## AMENDMENT NO. 3

**Project:** **Anderson County  
AgriLife Training Facility**  
603 N. Sycamore St.  
Palestine, Texas 75801

**ASI No:** No. 2

A3.01

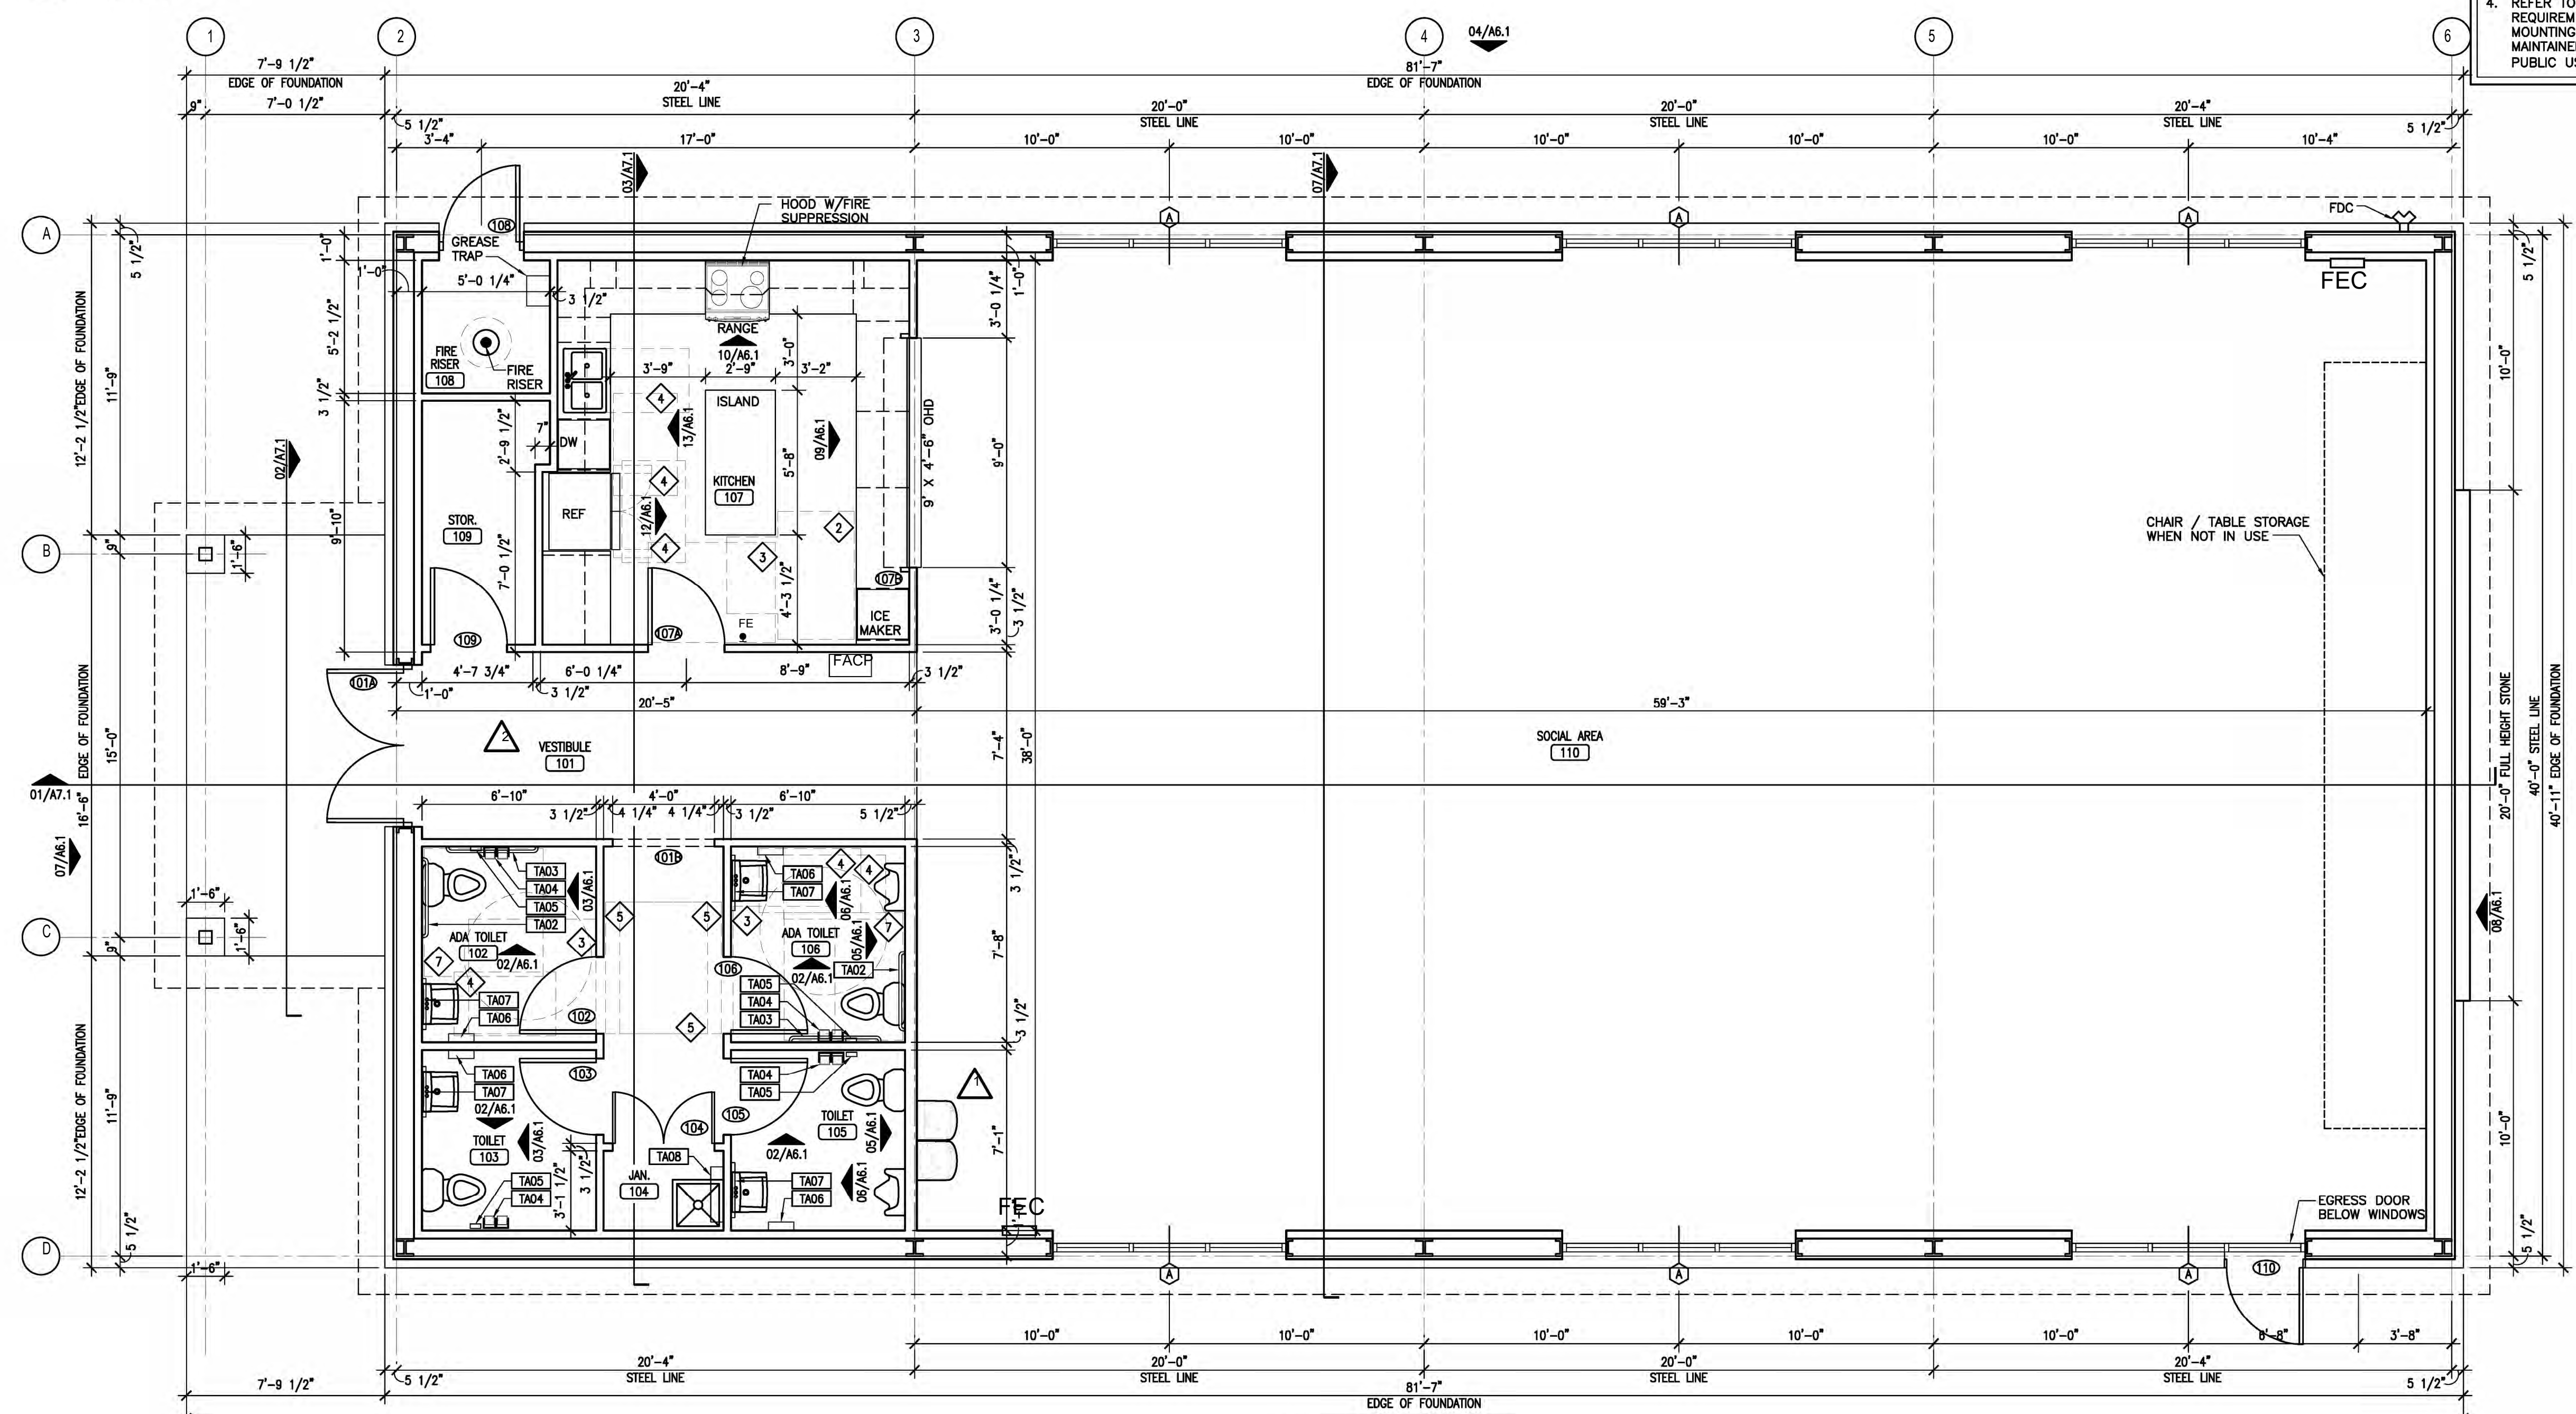
1. Door type tags were revised to correspond with the door schedule.

01 AV PLAN AND CONTRACTOR FF&E PLAN  
A5.01 SCALE: 1/4" = 1'-0"

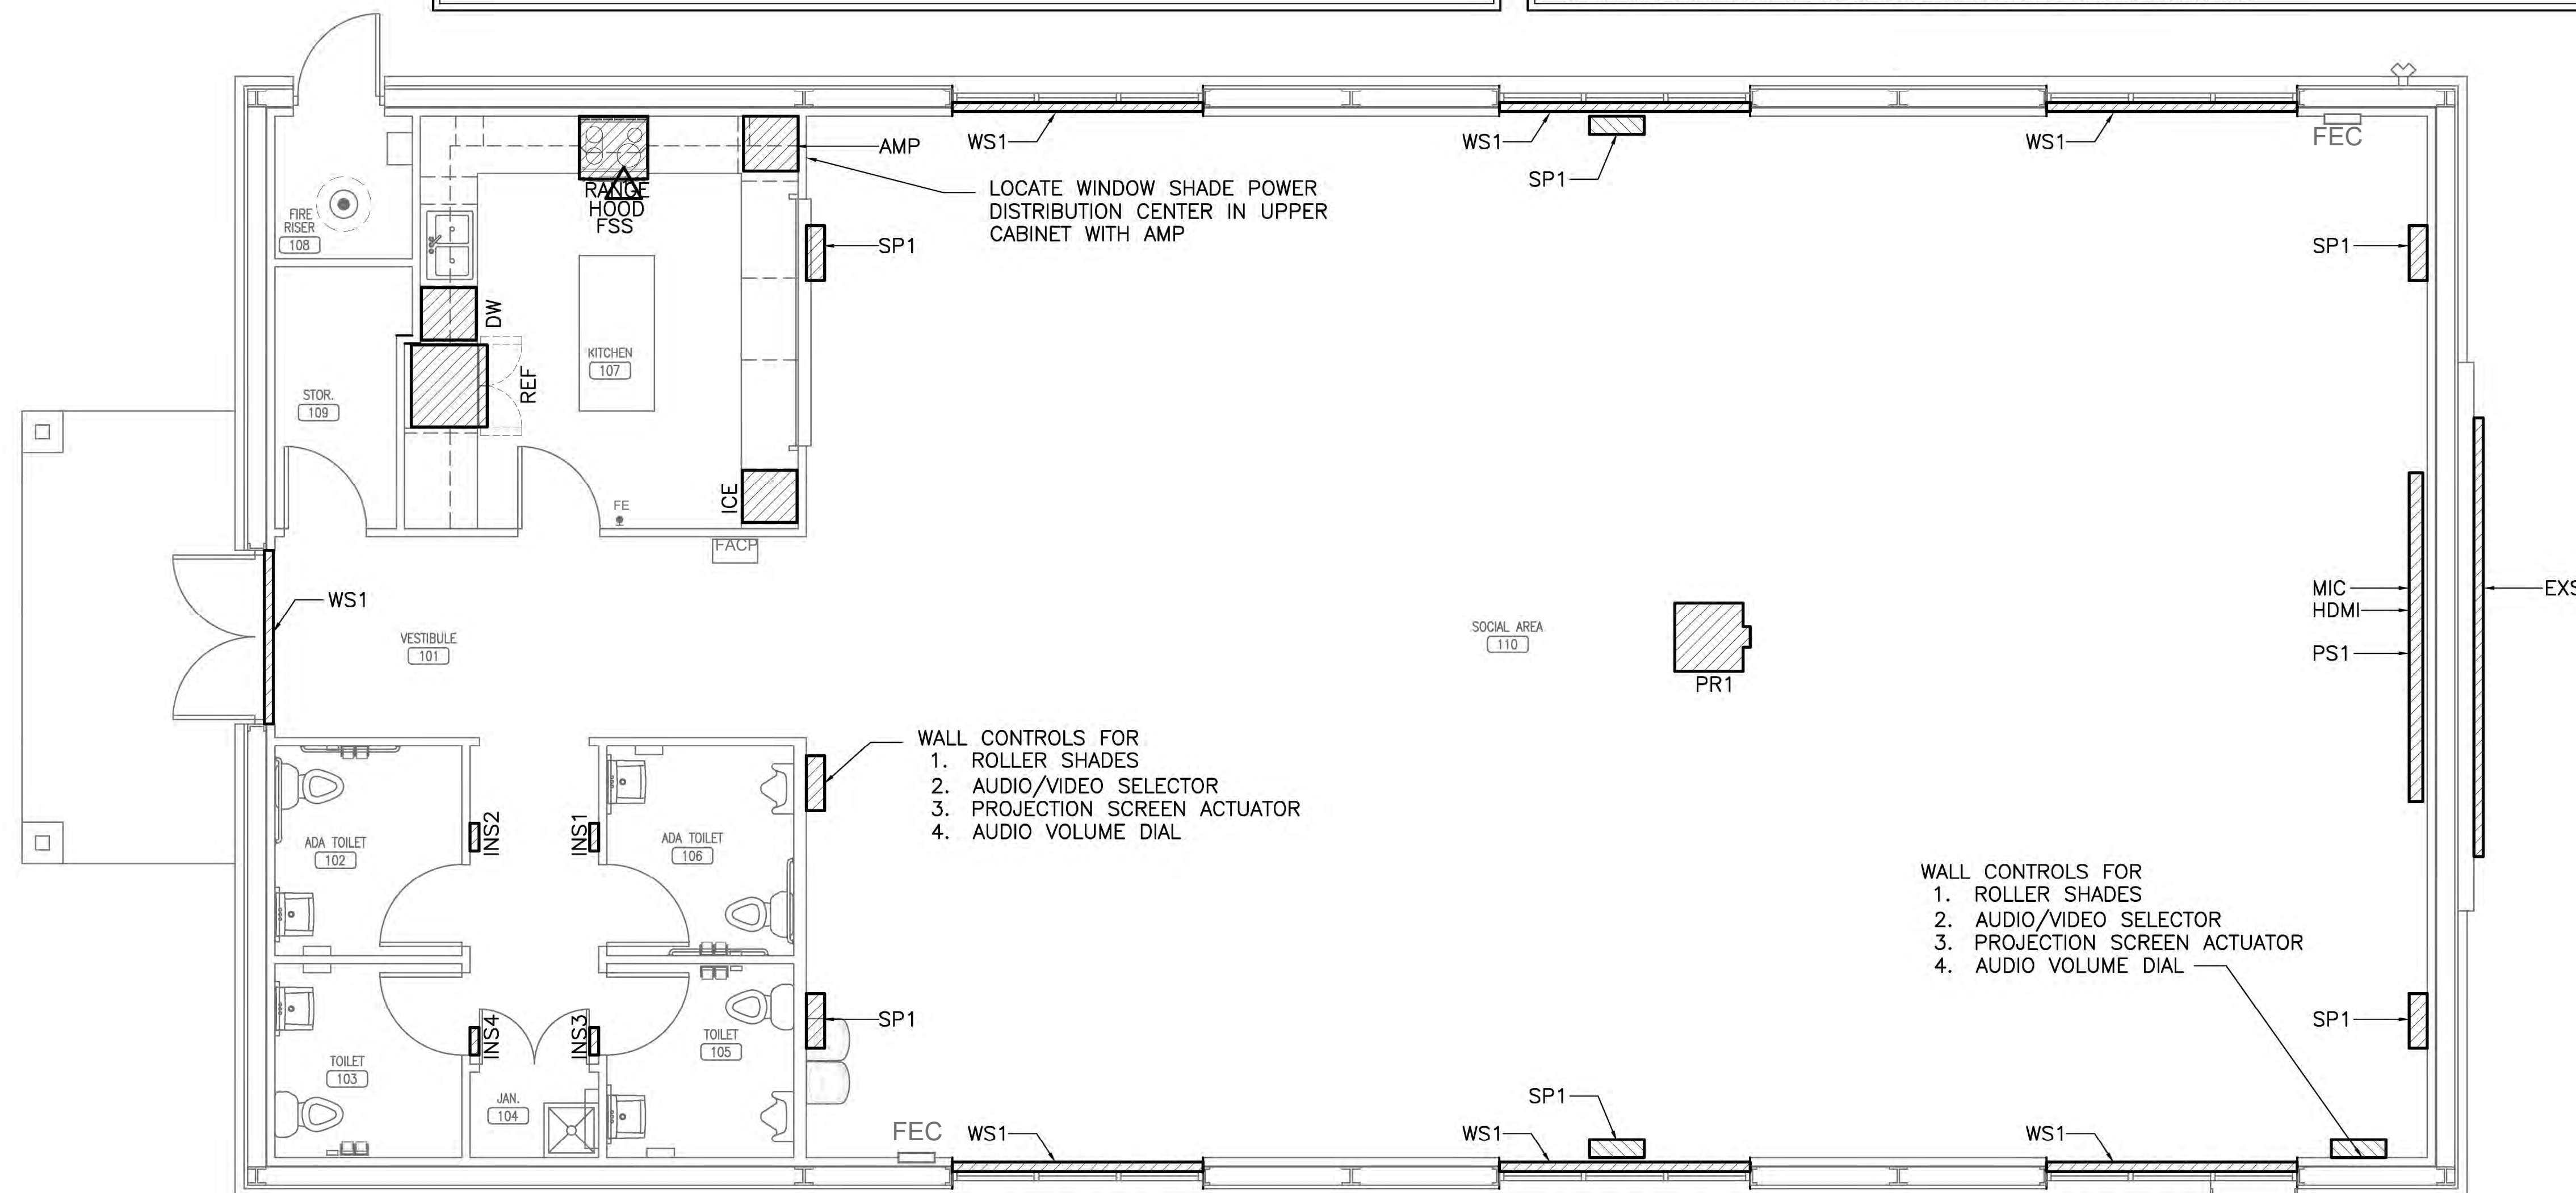
1. The sheet was revised throughout to address various bidding RFI's.
2. The A/V system is now required to be a design / build system within the contract for construction based on the performance criteria noted on the sheet.
3. Additional clarification was provided on the motorized shades.

FLOOR PLAN -  
POWER

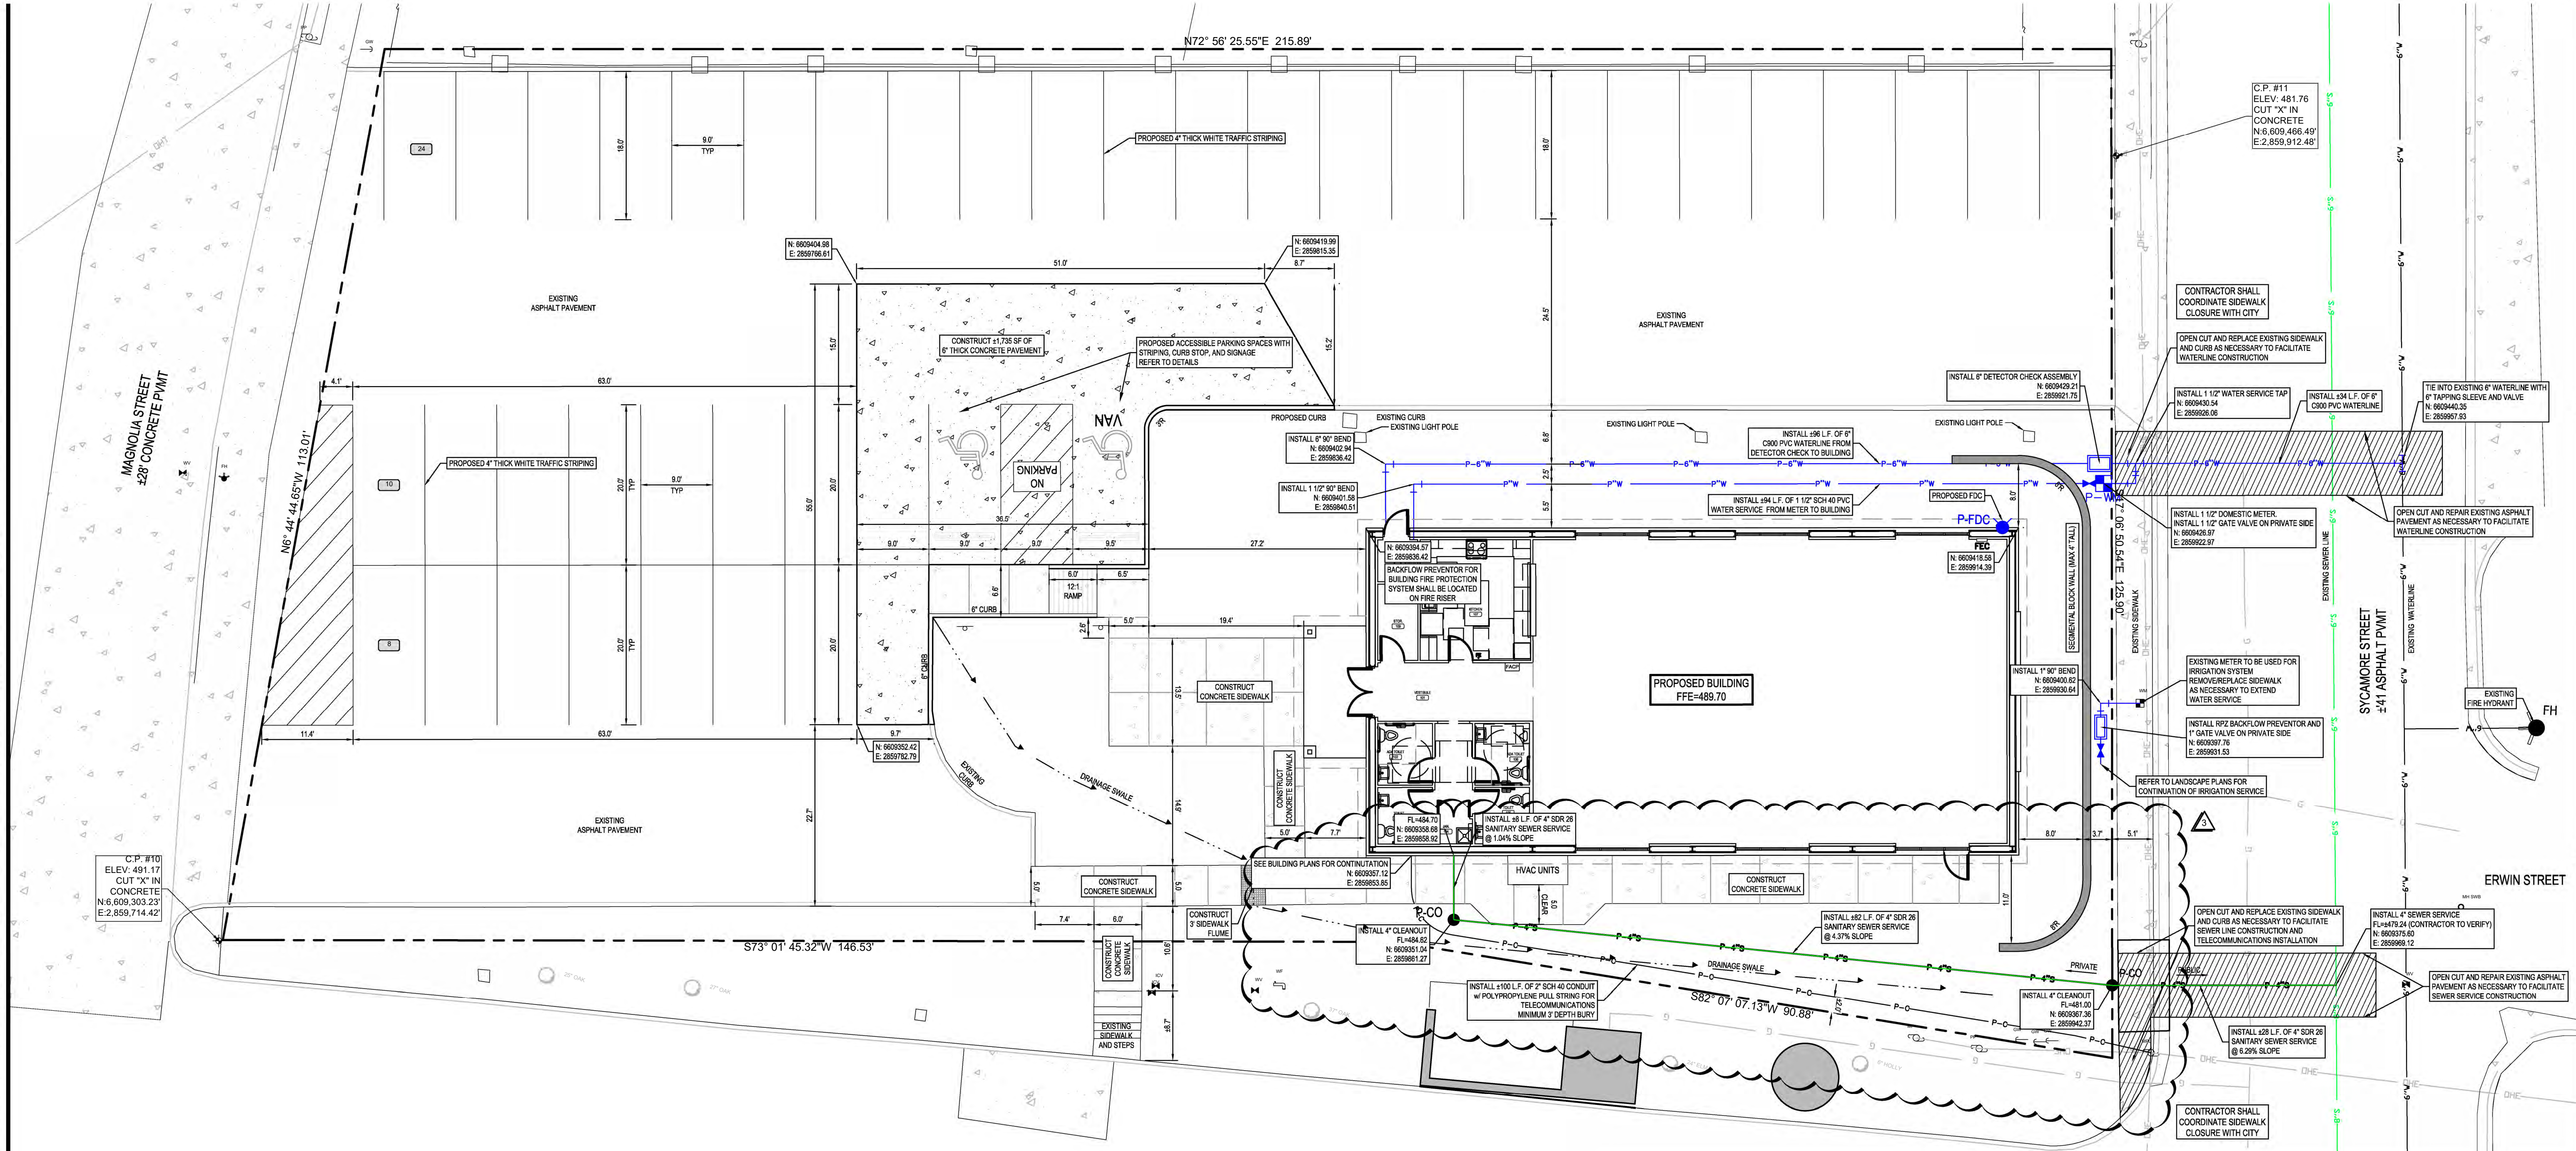
1. A 2" conduit for telecom was added from Storage 109 to the electrical pole in the right of way.
2. Wireless access points were added to the plan.
3. The electrical outlet for the A/V equipment was noted to be in the back of the upper cabinet rather than the ceiling.
